# Transmitter Output Waveform Requirements

Adam Healey

Agere Systems

September 12, 2005

# Test Methodology: Resolution

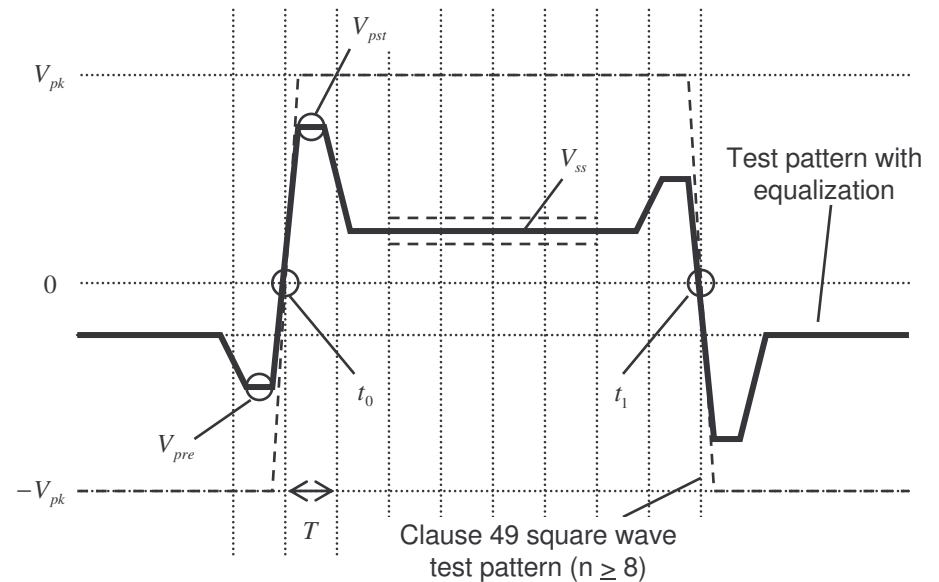
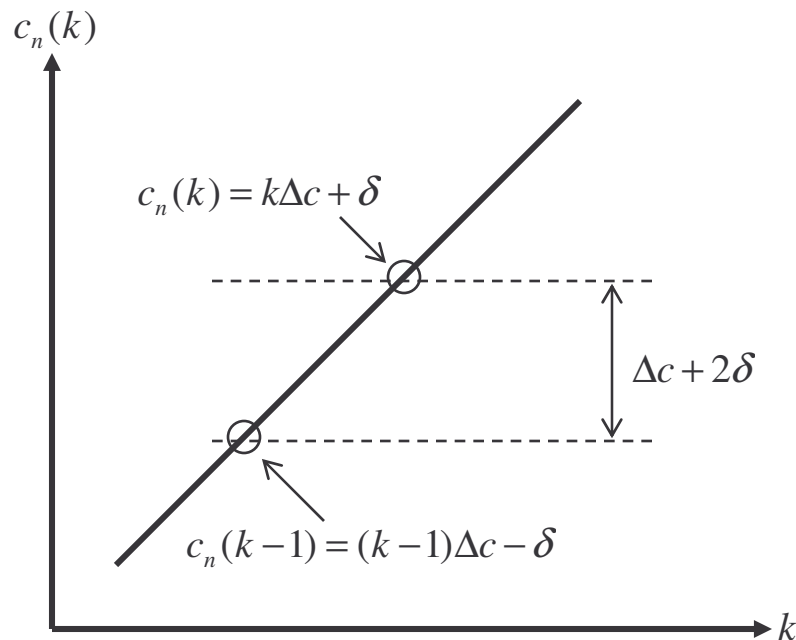
- Define  $D_{pre}$ ,  $D_{pst}$ , and  $D_{main}$
- Verified at all adjacent equalizer states, i.e. the results of a single *increment or decrement* on  $D_{pre}$ ,  $D_{pst}$ , or  $D_{main}$

- $D_{pre}$  and  $D_{pst}$  values are not correct
  - Should be  $\Delta c(\max) + 2\delta(\max)$  which is 0.0500 and not 0.0263
  - Must also factor in that  $V_{pk}$  may vary from state to state
- $D_{main}$  requirements do not align with other requirements
  - Expressed as an absolute voltage, making percentage a function of the full-scale amplitude
  - Effective step size should not vary from  $D_{pre}$  and  $D_{pst}$  step sizes
    - 30 mV is appropriate for 600 mV<sub>pd</sub> full-scale amplitude, 20 mV for 400 mV<sub>pd</sub> full-scale amplitude
  - It is not clear that  $c_{-1}$  and  $c_1$  are to be held constant as part of this test

- Align specifications to what was adopted at the May interim
- Eliminate the requirement than  $V_{pk}$  be kept constant throughout the equalizer test
  - Acknowledge independent control of  $c_0$
- Make test conditions for each requirement abundantly clear
- Note that, from the original requirements for pre- and post-cursor range:
  - $R_{pst}(\max) = 1/(1-2*0.375) = 4.00$
  - $R_{pre}(\max) = 1/(1-2*0.175) = 1.54$

- Continue to employ the waveform decomposition methodology in 72.6.1.11
- Eliminate the current  $D_{pre}$  and  $D_{pst}$  definitions and replace them with simple voltage differences
- Differential output voltage limits are covered by the tables on the preceding page, and additional definitions, including those in 72.6.1.4, are redundant
